A Solitary Tree? STEM assessment method.

Resource Consent Application LUC-2017-372

Michie St Road Reserve, Dunedin

Comments on the Planner's Report by the applicant.

Figure 1 STEM evaluation form showing 1991 assessment

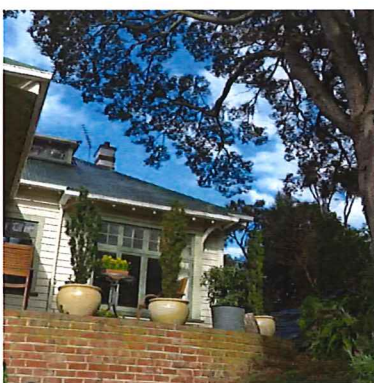
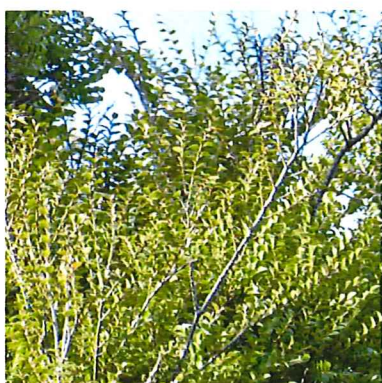
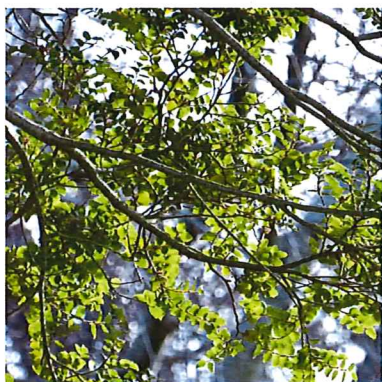
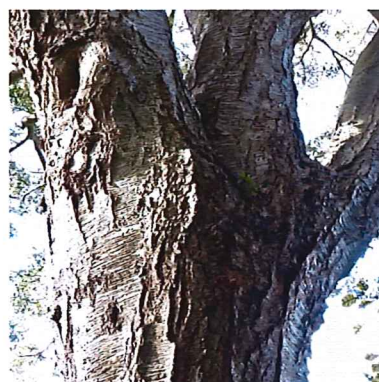
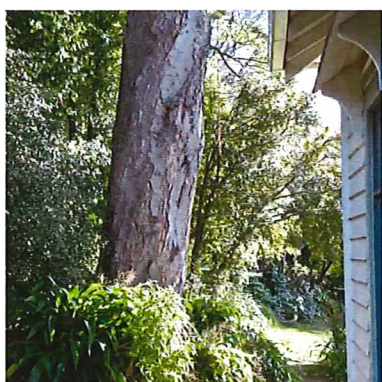
The initial STEM assessment in 2001 identified T790 as a solitary tree, scoring a maximum 27 points.

It seems from the Planner's Report that there may be an opinion that this assessment is still appropriate.

I maintain that scoring T790 as Solitary was not only inappropriate at the time it was first made in 2001, but that it is still inappropriate!

Nevertheless, a change in score for Proximity from 27 points (Solitary) to 15 points (10+ trees) is sufficient a reduction to justify removal on T790 from Schedule 25.3.

Figure 8 A 2015 Google Earth image showing location of 8 Michie St relative to the Town belt, showing Queens drive in the lower right and the Belleknowes golf course in the upper right. Also shown are approximate locations (1-4) of photos in Fig. 12.

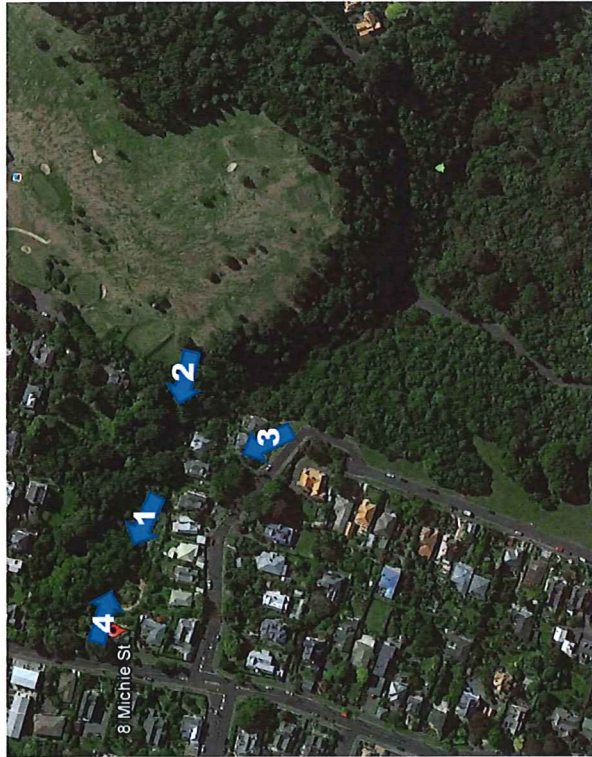
It is apparent from figures 8 and 9 that the road reserve was densely vegetated in 2005. It is reasonable to assume that this was the case also in 2001 when the initial STEM assessment was made. The road border was planted following widening of Michie St in 1971-1972 so the trees apparent in the 2005 aerial photo were close to 30 years old then.

Figure 9 A 2005 Google Earth image of the valley containing T790, 4 years after the existing STEM assessment.

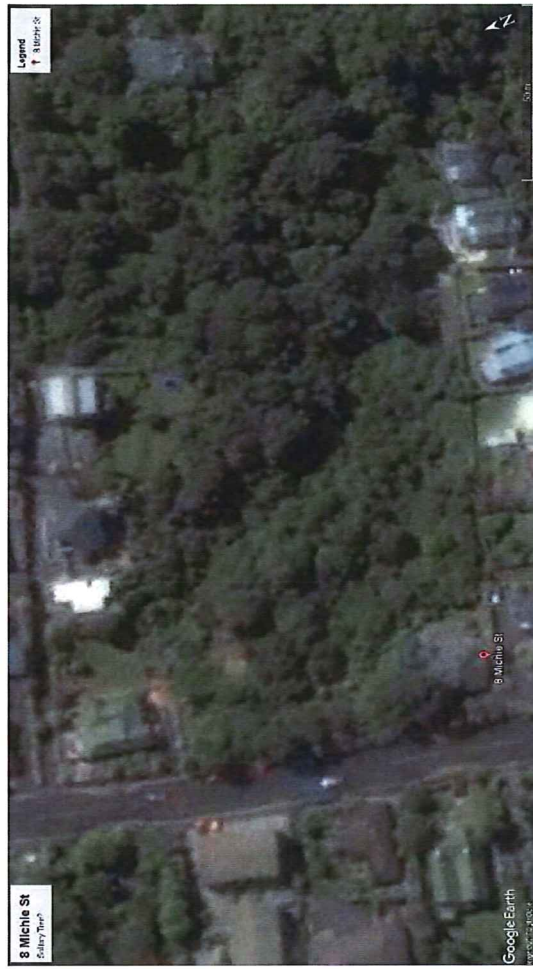
Figure 9 Google Earth Image 2005, 4 years after the initial STEM assessment of T790. The visible bush covers almost all of the 0.45 ha of 8 Michie St. The 2/3 of the 8 Michie St section in the centre of the image is included in Urban Landscape Conservation Area 01 in the Dunedin District Plan i.e. The Town Belt.
